RE: OPA21.008, ZBA21.008, and SPA21.31  
6461-6587 Main Street Stacked Townhouse Development Proposal

We have had a chance to do an initial review of the documents that were submitted as part of the applicant’s complete submission with respect to **Zoning, Land Use, Groundwater, and On-Site Storm Water Management**. As a result of our review, we have a number of questions and observations that we would like to offer to the Town.

Figure 6: Definition of first storey

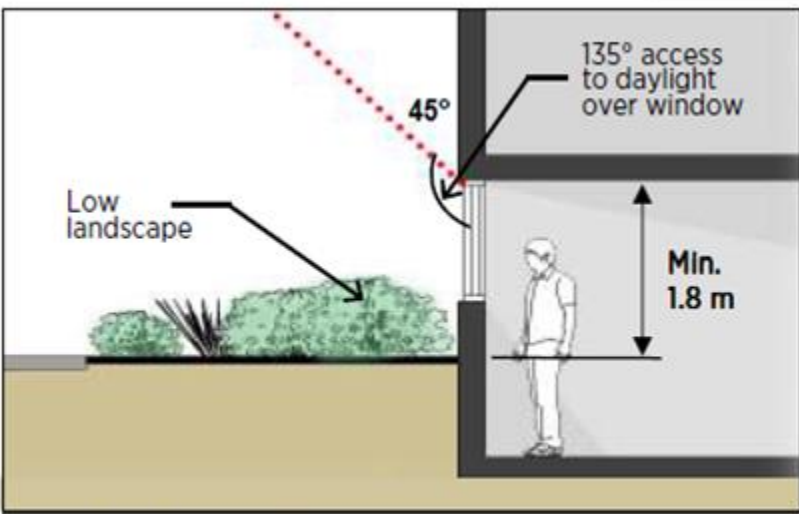
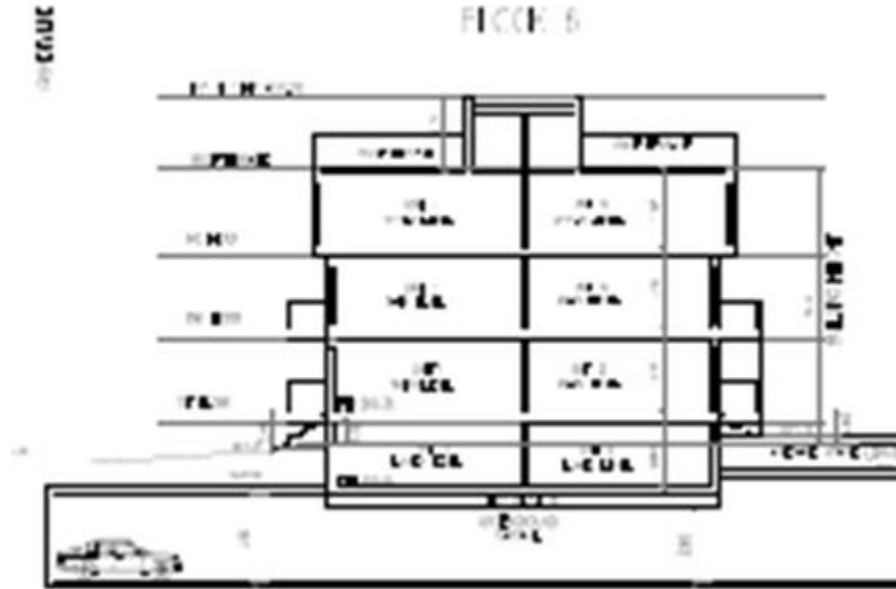
What is the Town's definition of a "storey"? Below is a cross section of the proposed building, along with Mississauga's definition of what constitutes a "First Storey" level.

Using this definition of a first storey, it appears as if the proposed development, due to its raised basement built on top of the parking garage, is actually four storeys PLUS a roof terrace and mechanical room/staircase installation. Four storey buildings in RN4 zoning are not permitted. So is this a three or four storey building? Can you provide the zoning bylaw that defines what “a storey” is?
